Fishermans Bend Planning Review Panel

Draft Amendment GC81 in the Fishermans Bend Urban Renewal Area – 61, 140 & 155 Bertie Street, Port Melbourne

STATEMENT TO THE PLANNING PANEL APPOINTED BY THE MINISTER FOR PLANNING FOR
AMENDMENT GC81 IN THE FISHERMANS BEND URBAN RENEWAL AREA BY CHARMAINE DUNSTAN,
TRAFFIC ENGINEER

Figure 1: Map 2 Street and Laneway Layout

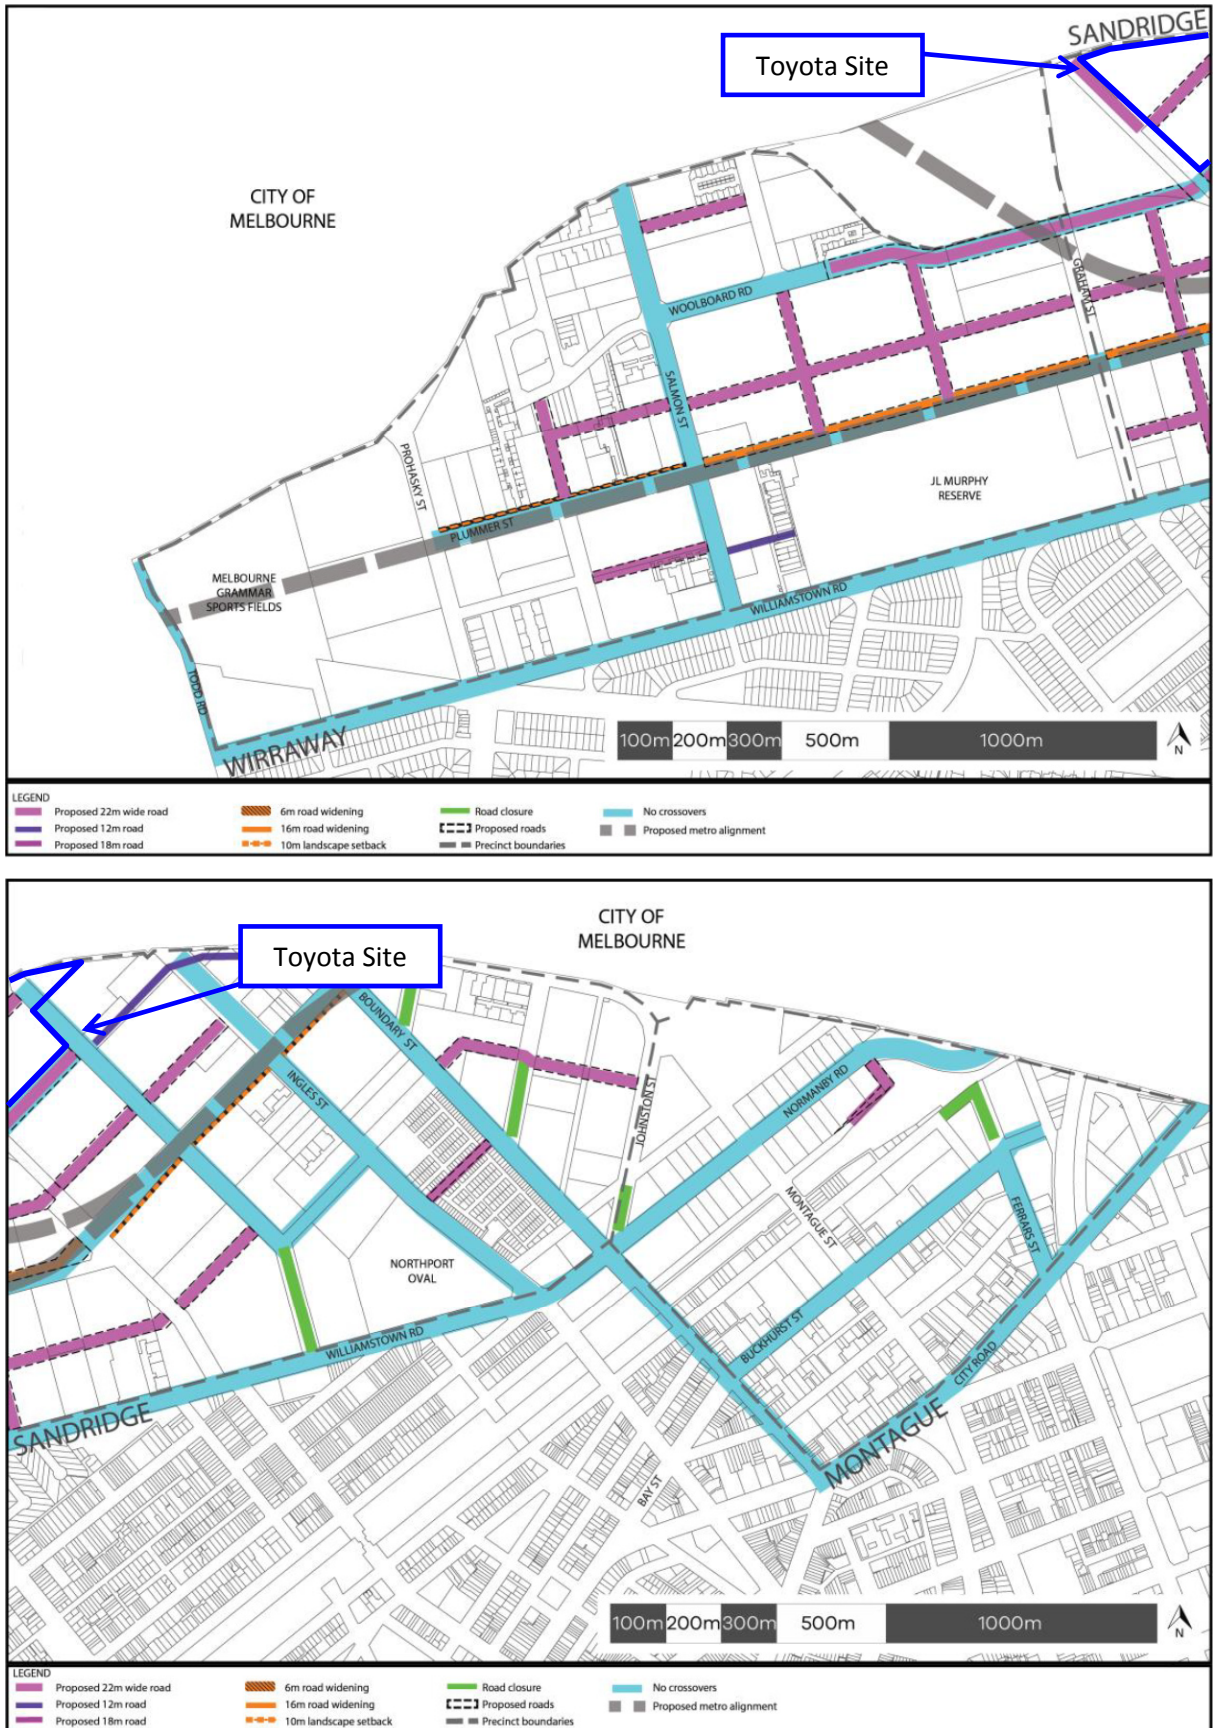
The traffic/transport issue most critical to Toyota is the lack of discretion within the revised DDO, which would potentially require the delivery of a 22m wide road that bisects the CHQ building at 155 Bertie Street, Port Melbourne as part of any application affecting the land.

A permit must not be granted to construct a building or construct or carry out works where the provision for any new streets, laneways, or public open space generally in accordance with Map 2 and Map 3 is not provided.

Map 2 relates to new roads and is reproduced in Figure 1 below.

Firstly, in my view the above requirement is not clear. It can be read that any application for building and works triggers the requirement to deliver the road detailed on Map 2 of the controls or it could be read that it only applies in the event that building and works are proposed that would affect the part of the land described in Map 2.

Under either scenario, the controls do not provide sufficient flexibility to cater for an existing use that intends to continue on the site for the foreseeable future and would likely apply for building works that enable the site to continue to adapt and accommodate the business requirements of Toyota.

The road identified as bisecting the CHQ building and carpark is nominated as having a 22m wide road reservation. This road is expected to serve an access function to abutting properties, noting that the controls do not prohibit or discourage crossovers to this road. In contrast, the 22m road to the immediate south-east of the Toyota site is proposed as a no crossover road and forms part of the Woolboard Road extension, which includes an off-road cycling path.

The 22m road that bisects the site serves no through-traffic function and simply acts as a link between the extension of Bridge Street and Bertie Street, and allows access to abutting properties (i.e. only the subject site).

In my opinion, the road that bisects the Toyota site should be deleted from Map 2 in the controls and Figure 8 in the Framework Plan. Alternatively, the controls need to include a mechanism to be able to apply discretion in cases where a planning application is made for works which relate to the continued operations of an existing use of building, so that there is not a mandatory requirement.

Figure 2: Aerial Photograph of Site and Proposed Road

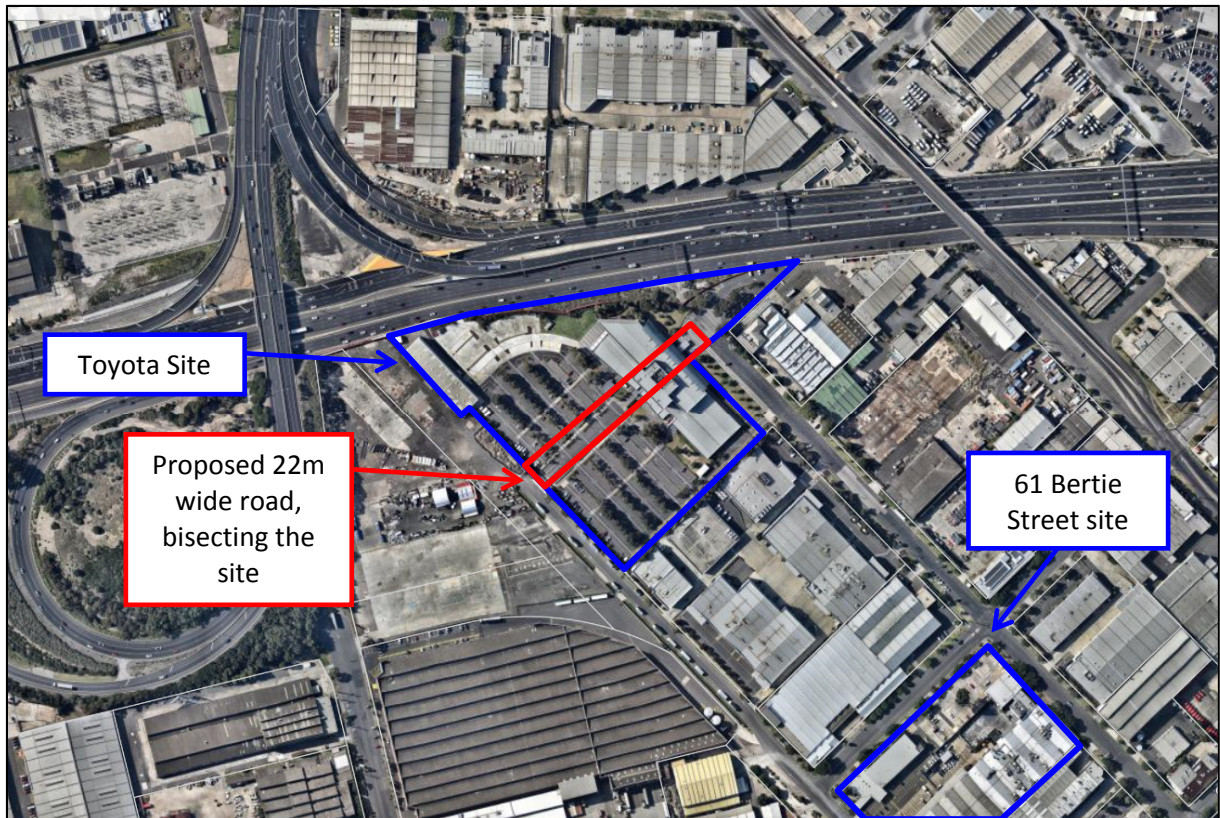
An aerial photograph provided at Figure 2 details the approximate location of the road which would bisect the site in the event of any planning application on the site.

Figure 3: Draft Fishermans Bend Framework – Figure 8

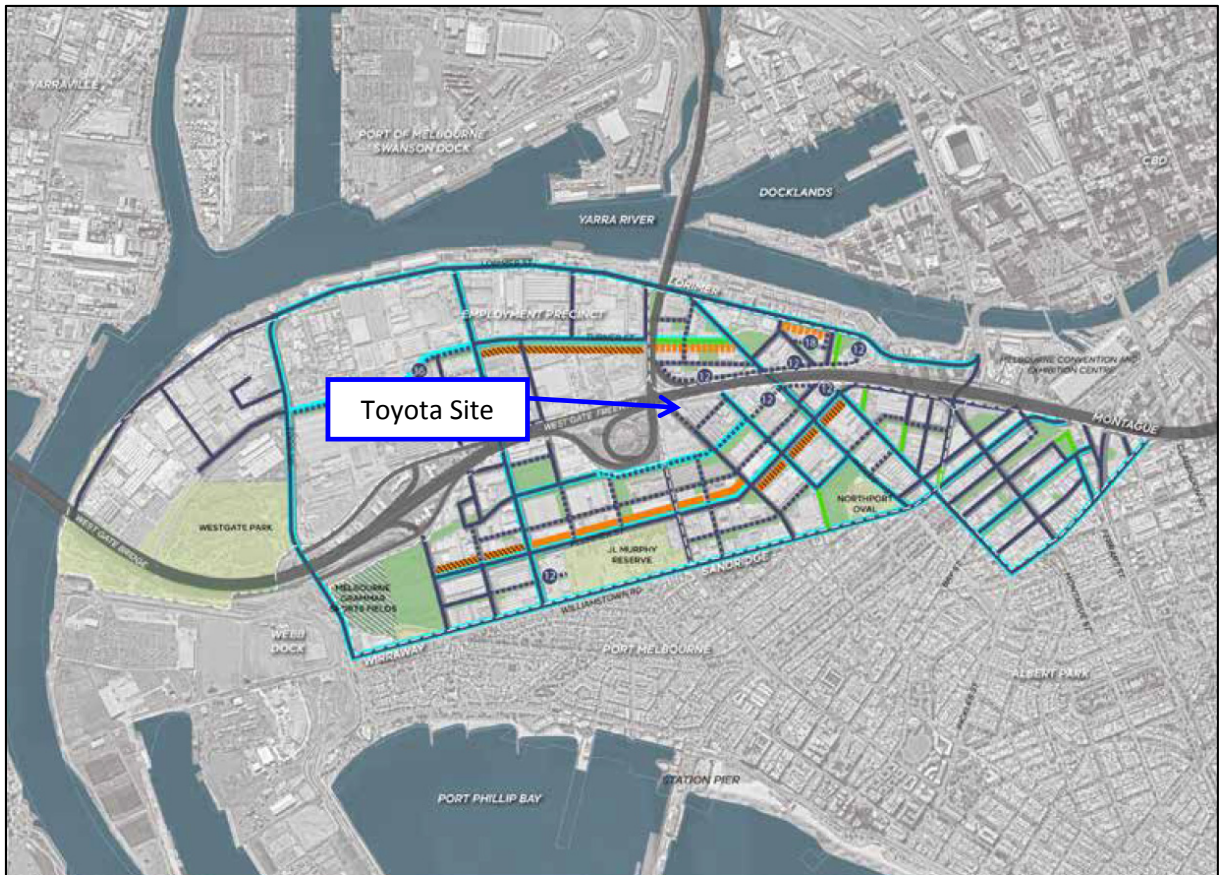
It would appear that its inclusion relates to the broader objective of creating *“a fine grain, permeable street network through the creation of new streets and laneways and ensure intersections are aligned to maximise connectivity”*.

This particular road is not about alignment, but about general spacing of roads. The configuration of the road through the centre of the Toyota site ensures that the access objectives of this road only become relevant at the redevelopment stage for this site (when abutments to a finer grain network are sought). The objectives are not relevant whilst the CHQ building exists and Toyota is operating under its current configuration. Any attempt to achieve a public road connection in the interim would be detrimental to the functionality of this site to meet Toyota’s current and potential future needs. Toyota operates a secured site (with access via boom gates and enclosed by security gates after-hours) and seeks to continue to do so.

Figure 4: Walking, Cycling and Traffic Plans – Integrated Transport Plan

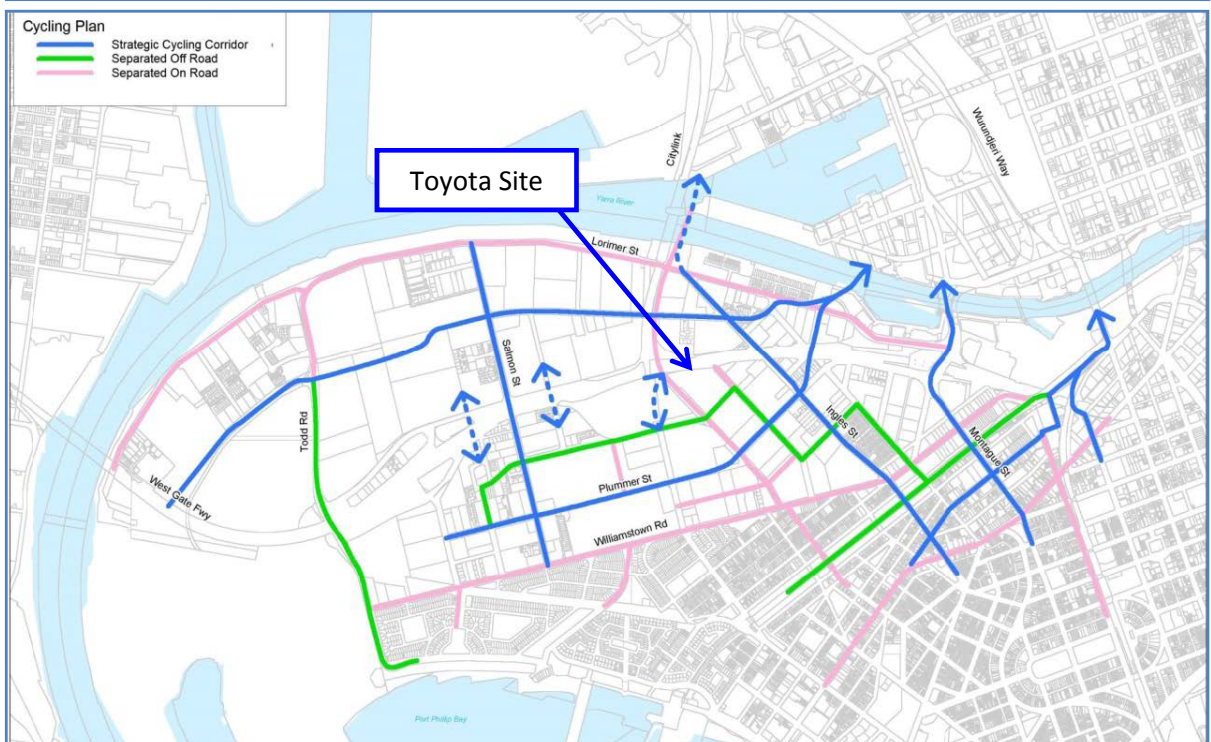
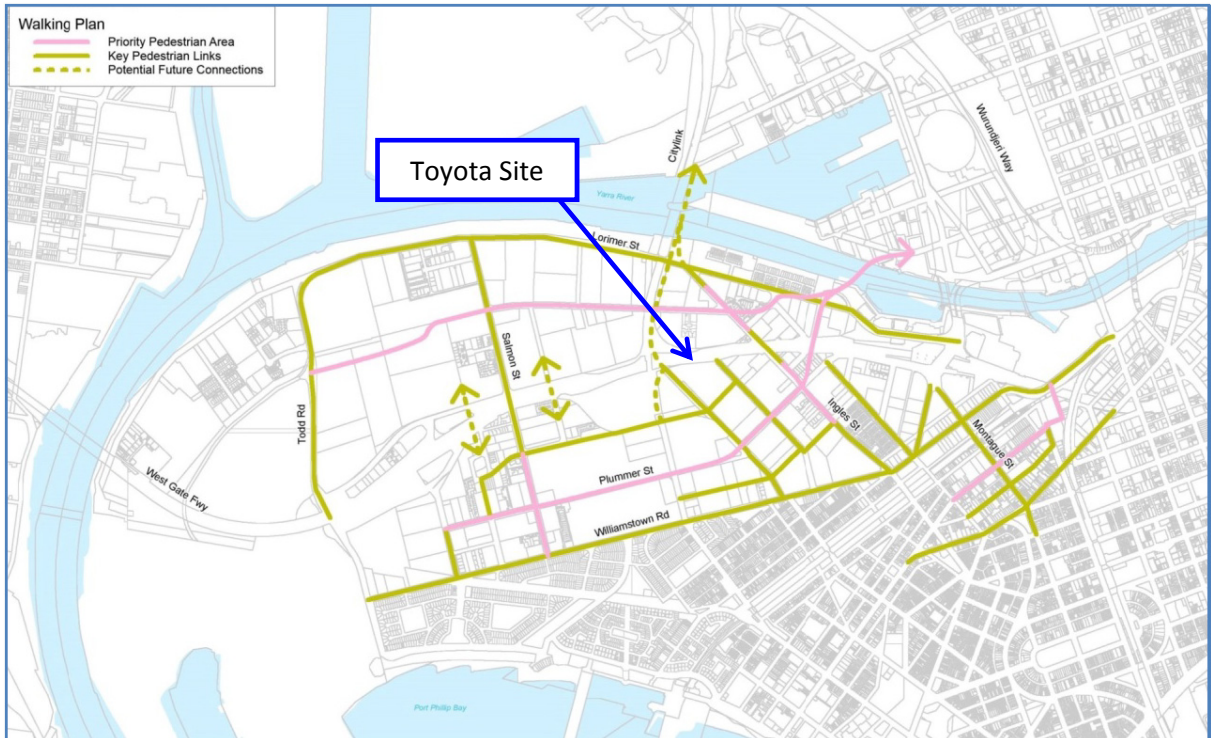
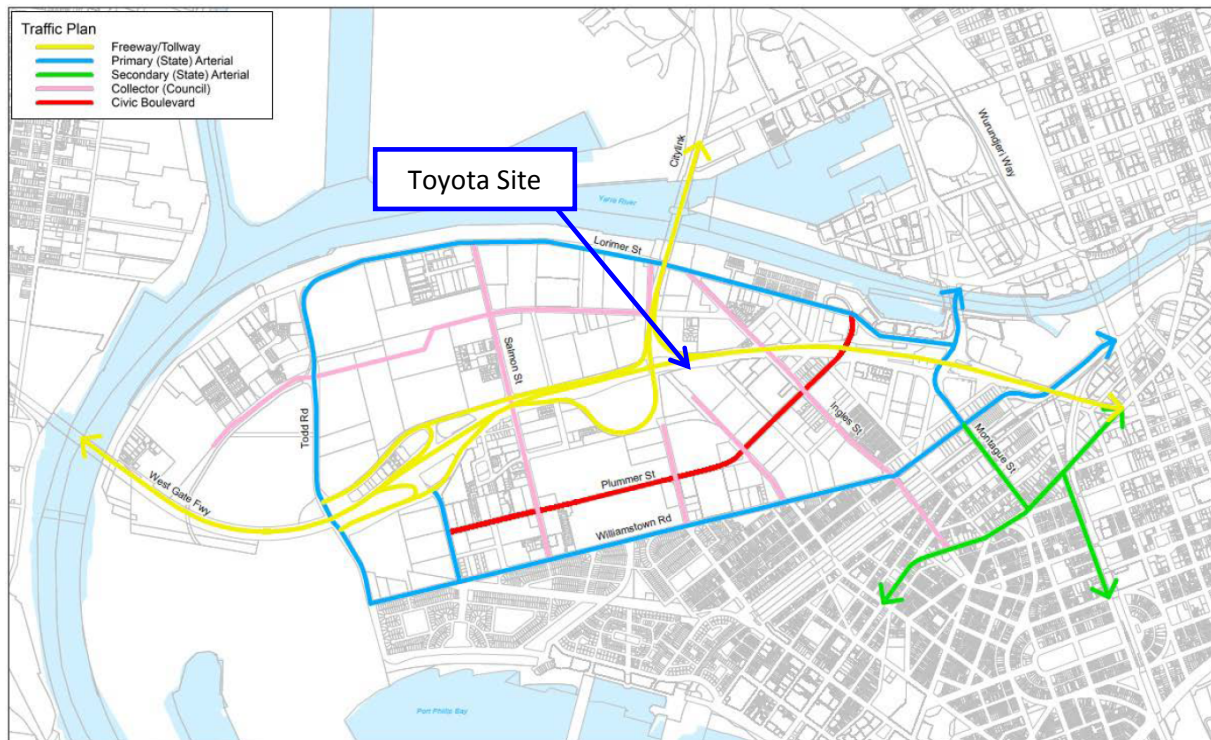
It is clear from the above figures and extracts from the Draft Fishermans Bend Framework and Integrated Transport Plan that the purpose of the proposed road bisecting the subject site is primarily to provide for property access.

The road is not identified as a key pedestrian link within the Walking Plan.

The road is not identified as a cycling corridor or having an on-street bicycle connection on the Cycling Plan.

The road is not identified within the Traffic Plan as a higher order road.

Figure 5: Map of Toyota Employee Count by Suburb

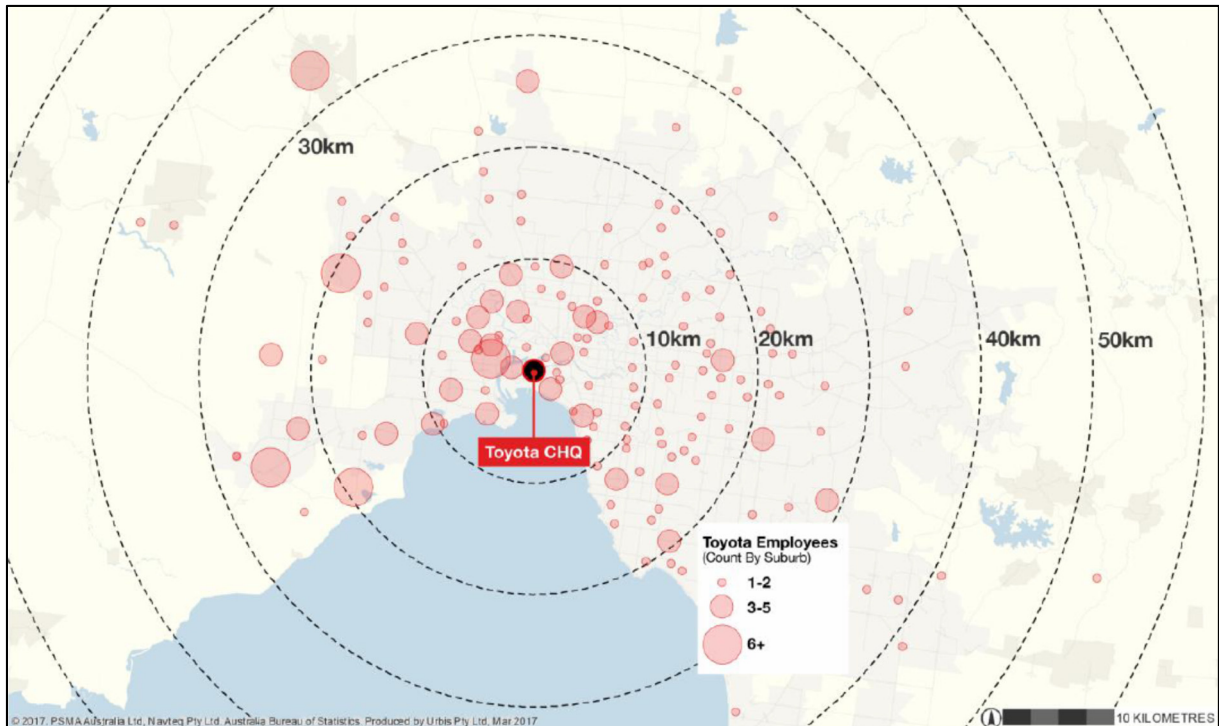
Toyota's current employee base is widespread throughout Melbourne and is mostly based within the middle and outer-ring suburbs. Given the low level of access to public transport for this site under current conditions, and historical employment base of the company spread across Melbourne, Toyota is heavily dependent on car-based travel for journey to work trips. Refer to Figure 5 below.

It is important for the Parking Overlay to allow for an empirical assessment of parking demands to inform part of Council’s consideration of a planning permit, due to its current profile of car parking demands. Toyota is a good example of where common sense in parking needs to prevail and the controls should allow for this to occur.
